OVERLAY DISTRICT
SITE PLAN APPLICATION

NAME OF PROPOSED DEVELOPMENT Murphy Bldg

MEMORANDUM

RE: Proposed Development Plan for FM-740

SITE PLAN

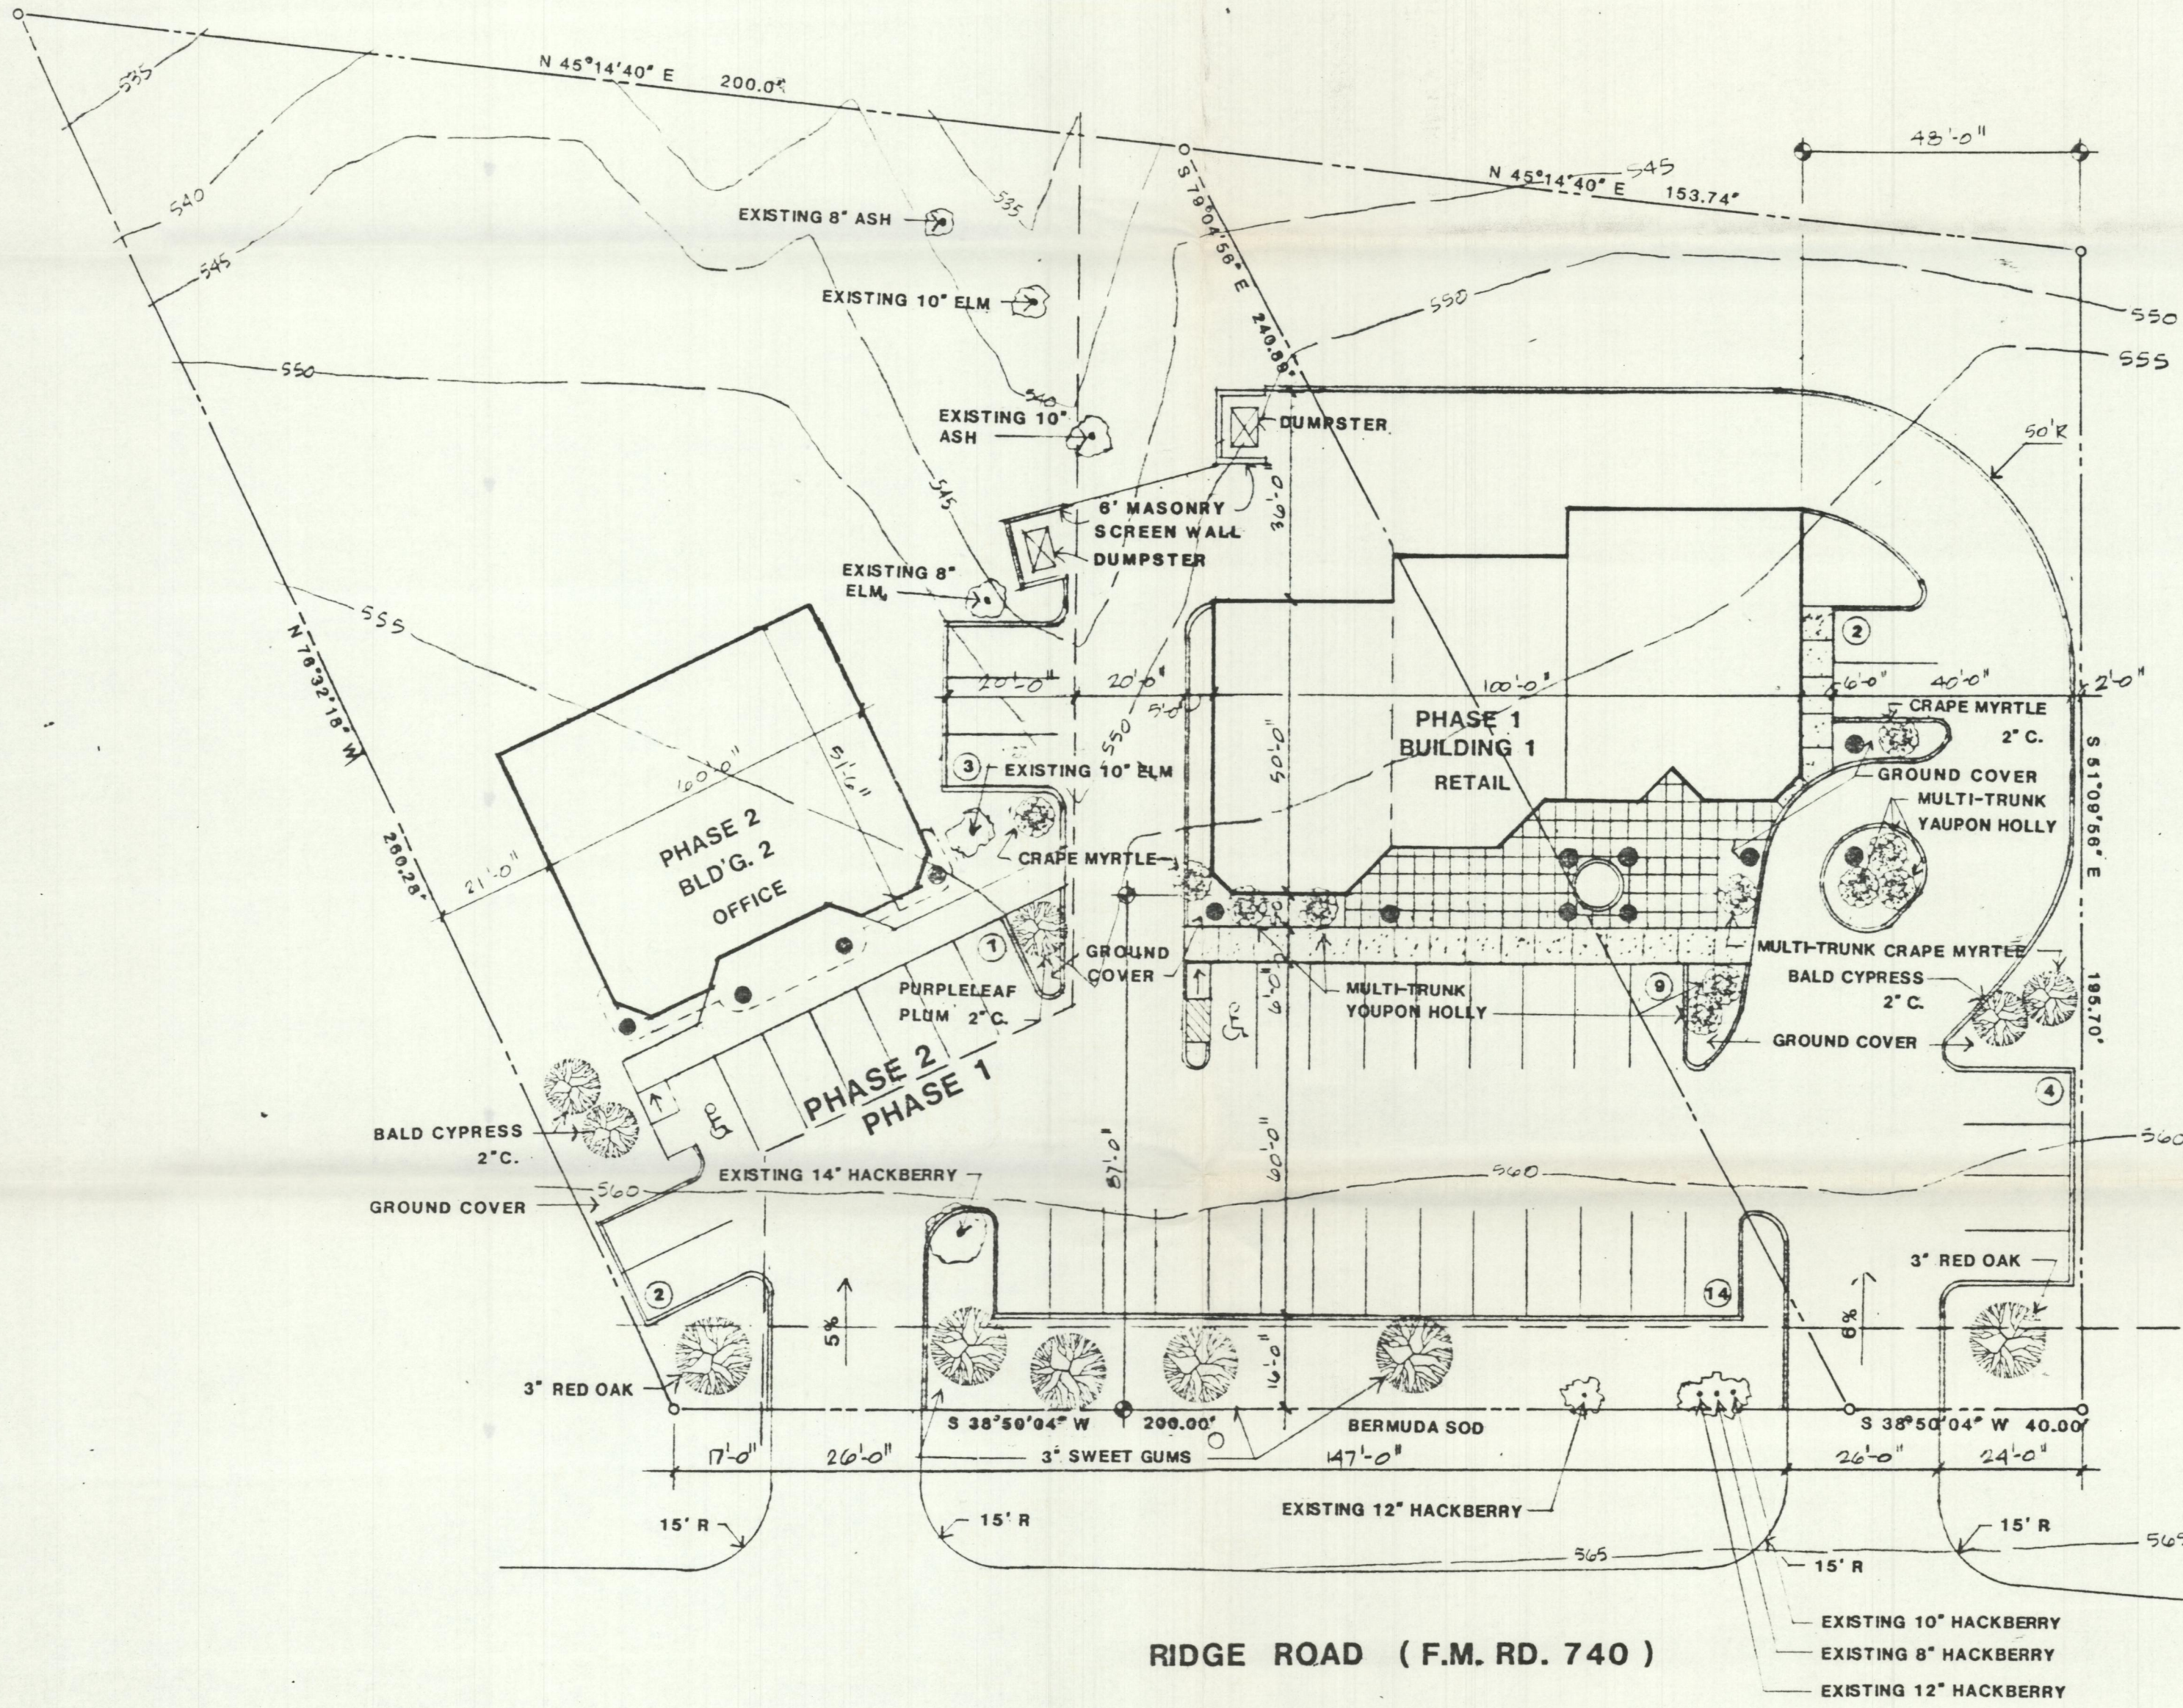
- c. Is the lot the proper size?
- d. Does the lot have proper dimensions?
- e. Are exterior materials correct? *what mat on side of*
- f. Are structural materials correct?

- g. Is coverage correct?
- h. Is adequate area in landscaping shown? *15% no enhancement*
- i. Is it irrigated?
- j. Is landscaping in parking lot required?

- o. Are driving lanes adequate in width? *rear drive 20' w/ 10' radius*
- p. Are parking spaces dimensioned properly
- q. Does the parking lot meet City specifications

- r. Is a fire lane provided?
- s. Is it adequate in width?
- t. Are drive entrances properly spaced? *close show 20'*
- u. Are drive entrances properly dimensioned?
-Do drive entrances line up with planned median breaks?

- v. Is lighting provided and correctly directed? *what type of lighting*
- w. Are sidewalks required?
- x. Are sidewalks provided?
- y. Is a screen or buffer required? *adjacent property use as of w/ 10' no less than 10' dist*
-Is it sized properly?
-Is it designed properly?
-Is it of correct materials?

does need to replat - has lot line over phase 1

just a few existing trees - you are trying to keep them

what about grand signage

1. There need to be 8 large trees identified along FM-740, currently there are 6.
2. In order to meet the minimum landscaping requirement of 10.5% the prospective owner has indicated that he will screen the parking lot with a 3' evergreen hedge. This needs to be reflected on the plan. The irrigated area needs to total 12.5% rather than 10.2% as currently shown with this addition of a hedge. This also needs to be reflected on the plan.
3. The site has 240 feet of frontage on FM-740 with two proposed driveway approaches that are 147 feet apart. Our standard separation is 200 feet. I indicated to Mr. Murphy that these two drives would not be inappropriate if the northern most drive was granted a public access easement that extended to the last three parking spaces along the north property line to allow a cross

connection in the future when the property to the north develops. This needs to be reflected on the site plan.

301 EAST ELEVATION

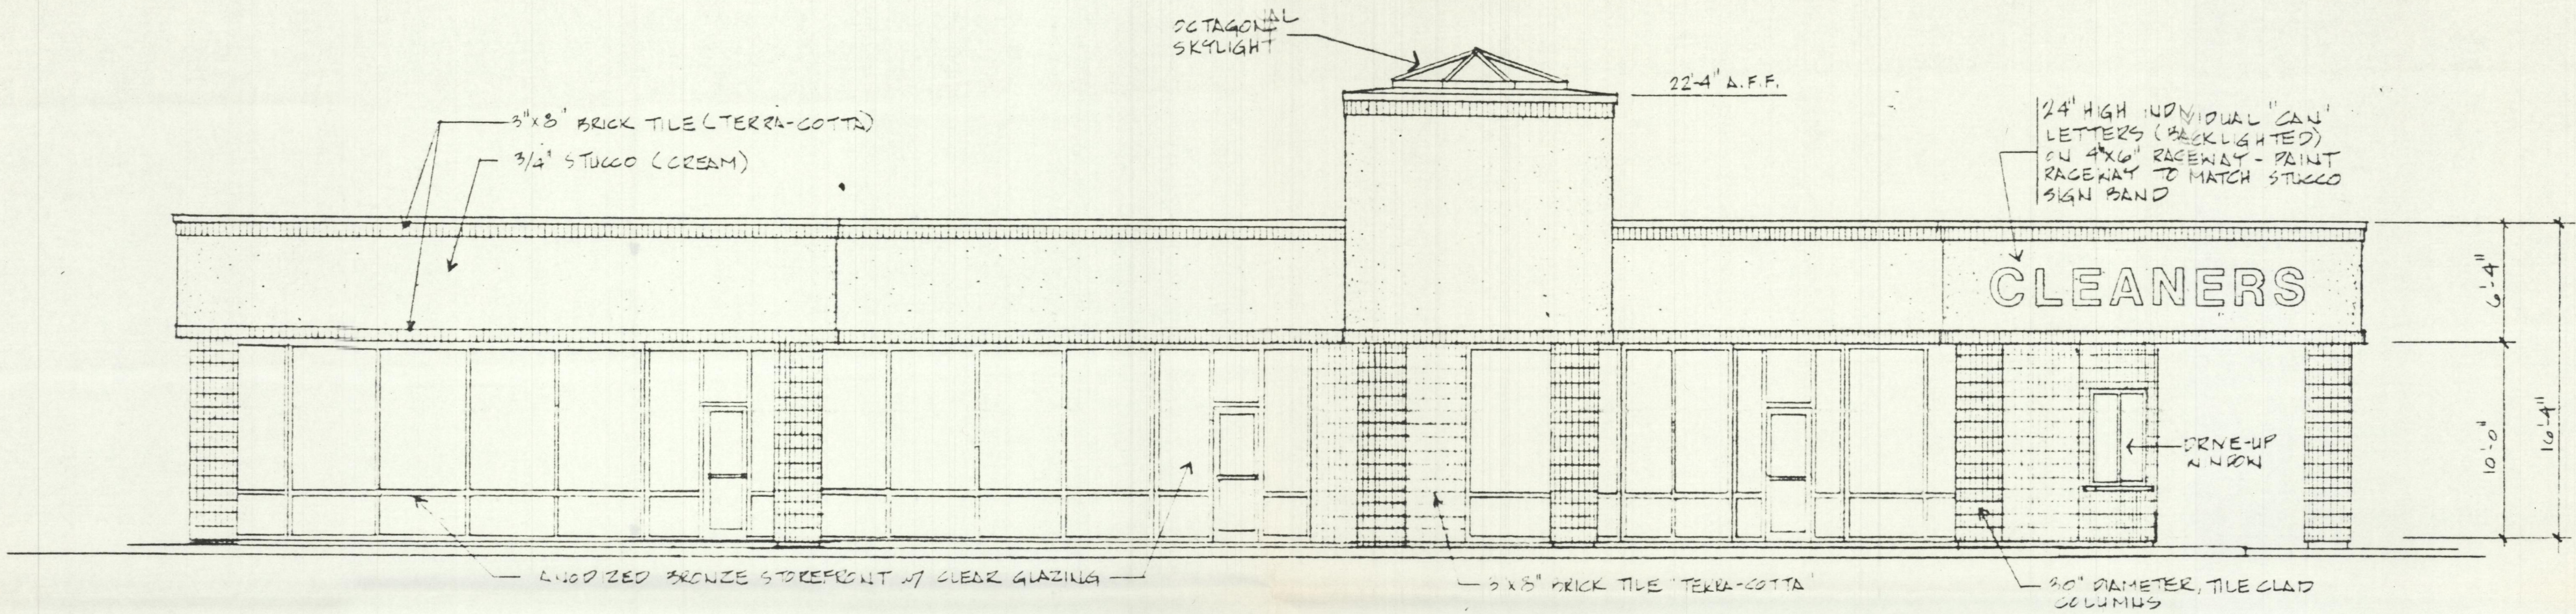
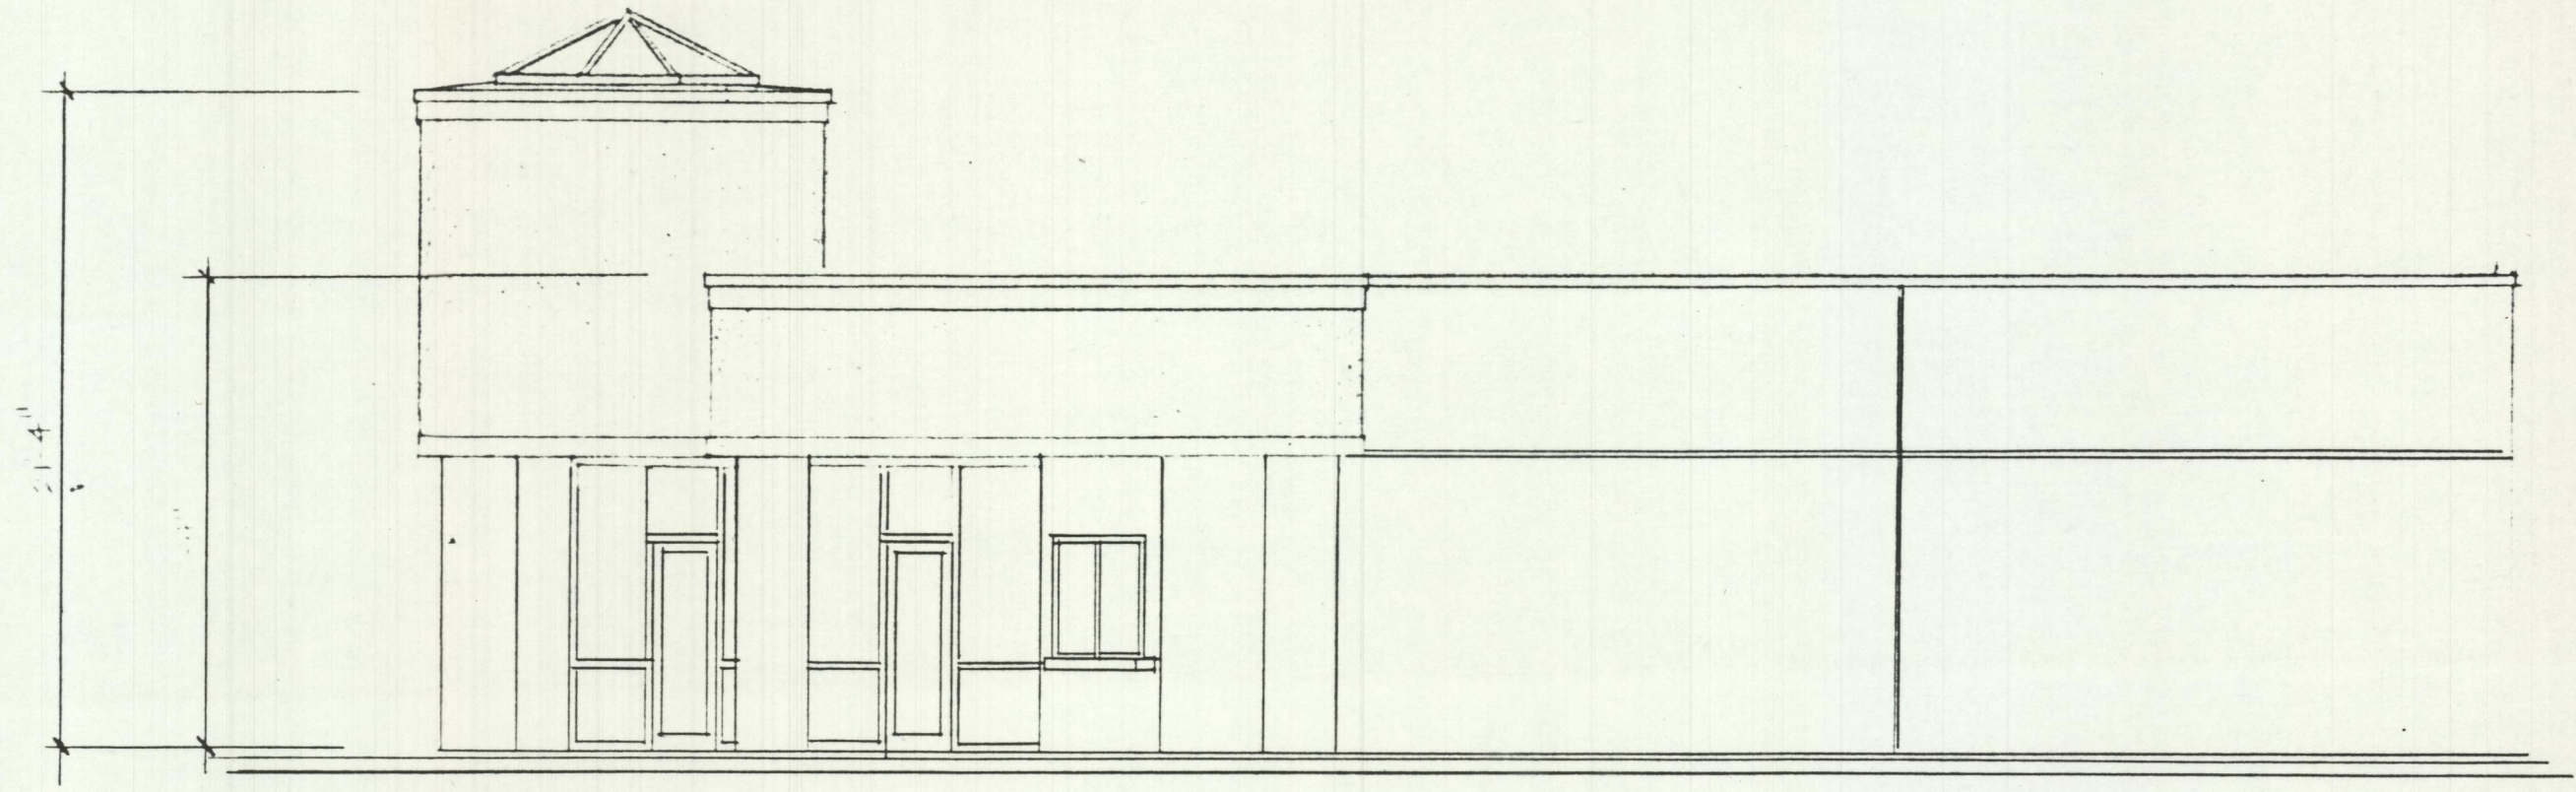
1. The building proposed is a tilt wall construction using a brick tile facade with a stucco band along the top of the building. The applicant proposes to only use the brick and stucco on the front of the building. He proposes to use a tinted aggregate that will blend with the brick and stucco along the sides and a tinted smooth tilt wall along the back. The south exterior wall of the first phase will ultimately be an interior wall and they will not want to brick that wall. The applicant is aware of the guideline indicating that tilt wall and stucco are not recommended within the District. His primary concern is one of cost, but he is aware of the past concerns of the Board and understands that his material may need to be upgraded. He does wish to discuss it with the Board.

2. The current roof design is a flat roof with a tower added for architectural variation. He does not include an elevation for the second building and he understands that he will need to bring that elevation back to the Board for your approval. He is aware that if the AC units and other equipment are roof mounted that they will have to be screened on all sides. I have indicated that a built up roof should be considered. They may place all equipment on the ground behind the buildings. This roof design is not a hip, gable or mansard roof and may not meet the goal of the Board.

Dany - on elevations show all external
penetrations + include a parapet wall on
all sides
Pick

1. That more detailed elevations of all four sides identifying all outside building penetrations, and actual location of materials along with color samples be provided to the Commission.
2. That a parapet screening wall be provided on all four sides of the building. The applicant only intended a short parapet wall along the front and sides that would not have screened the equipment on the roof.
3. That the applicant provide more detailed information on the turning radii for the drive through and the site circulation be provided and that the Commission consider only one entrance into the site, not two as originally proposed. The zoning ordinance recommends that a minimum of 200 feet separate drives on arterials. The Board did not feel that two entrances were justified.
